SANTA CLARA COUNTY FIRE DEPARTMENT

APPLICATION FOR USE OF ALTERNATE MATERIALS, METHODS OF CONSTRUCTION, OR MODIFICATION OF CODE

FIRE PREVENTION PLAN REVIEW COMMENTS

Alternate Means/Methods Application for an exception request to PRC 4290 - Proposed new 10 building 51-unit multi-family residential subdivision.

SETBACK SITE PLAN

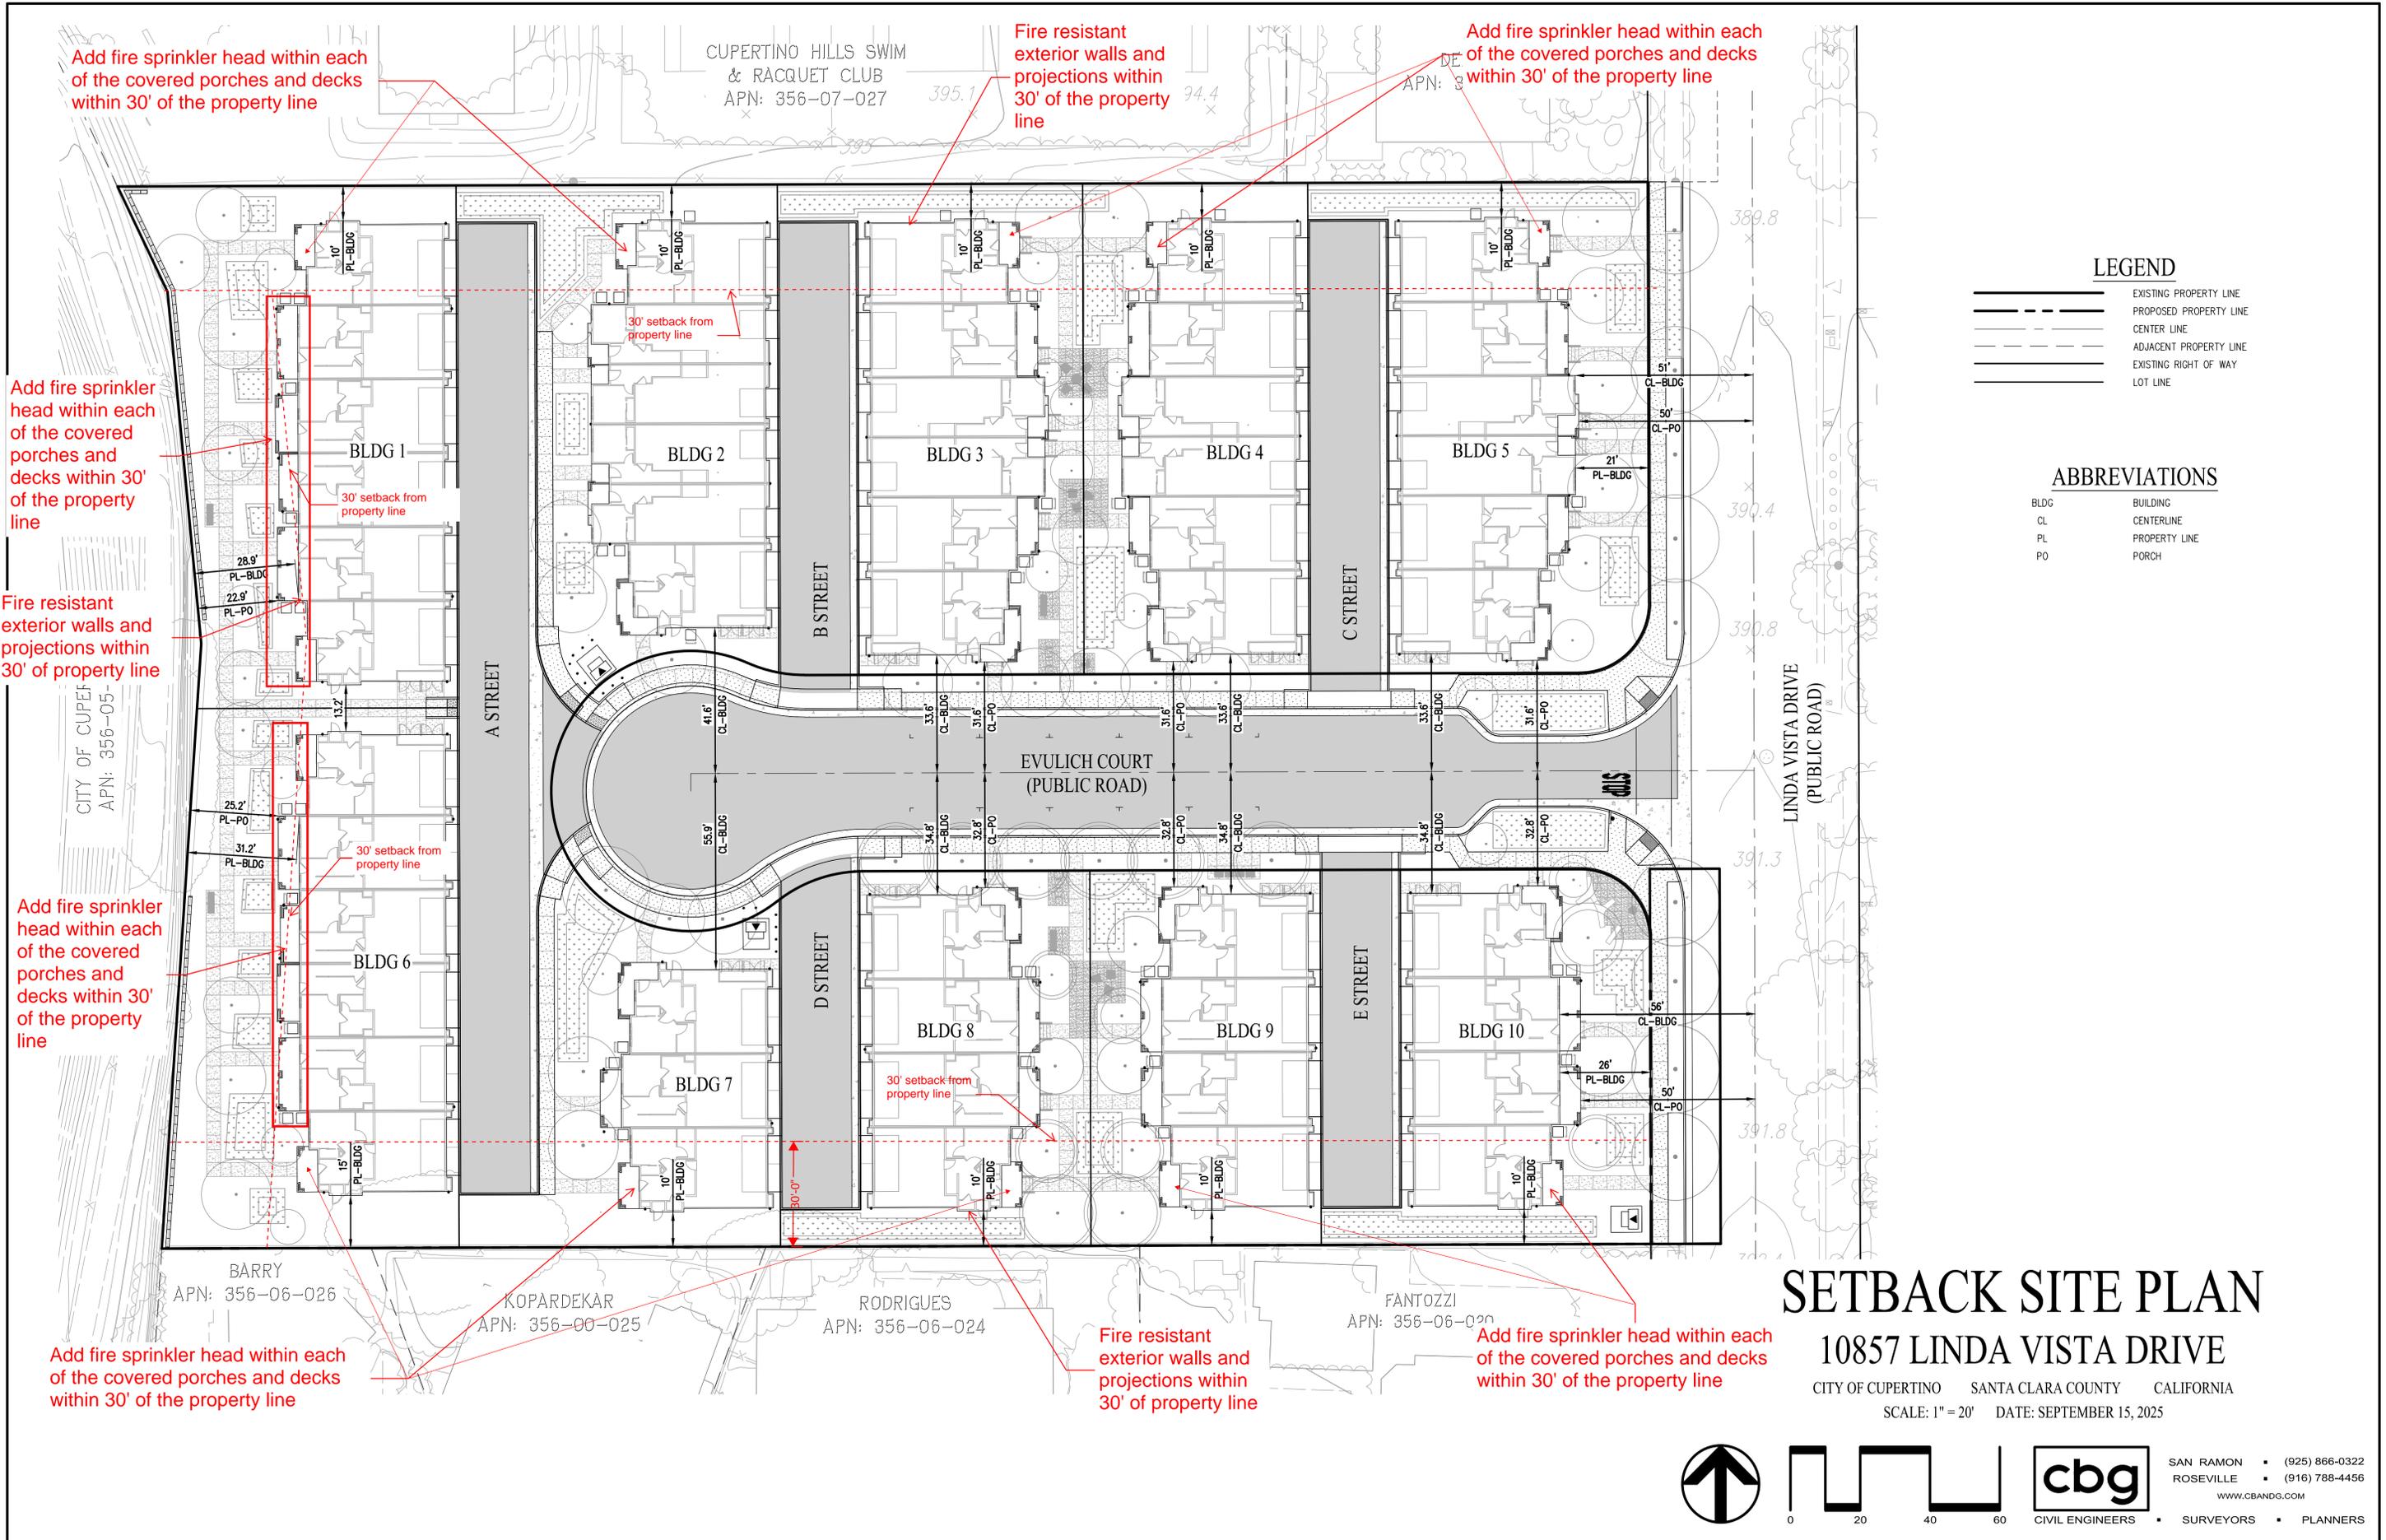
Request a reduction of the 30 foot setback from all buildings to the property lines as shown on the attached Exhibit A, which is consistent with the Development Permit plan set submitted to the City of Cupertino as file number TM-2024-009 and ASA-2024-015. In summary, the proposed setbacks to the public roads and property lines are proposed as follows:

2. Setbacks to Property Lines (Request for Reduction)
 - a. Northern Property Line: Minimum 10 feet
 - b. Southern Property Line: Minimum 10 feet
 - c. Western Property Line: Minimum 20 feet

The primary justifications for the reduction of the 30-foot setback requirement to the northern, southern, and western property lines are the development density requirements and site constraints due to the existing public right-of-way for the cul-de-sac within the site. Subsection (b) of the above listed Code includes Development density requirements and site constraints among the exceptions to the 30' setback requirement.

The exception request to PRC 4290 methods request is **APPROVED**.

- Add sprinkler heads to covered patios in all reduced setback areas.
- Design portions of buildings non meeting setback requirements to stricter fire separation distance requirements in accordance with CRC 302.4.
- Extend non-combustible landscaping 5 feet from buildings.
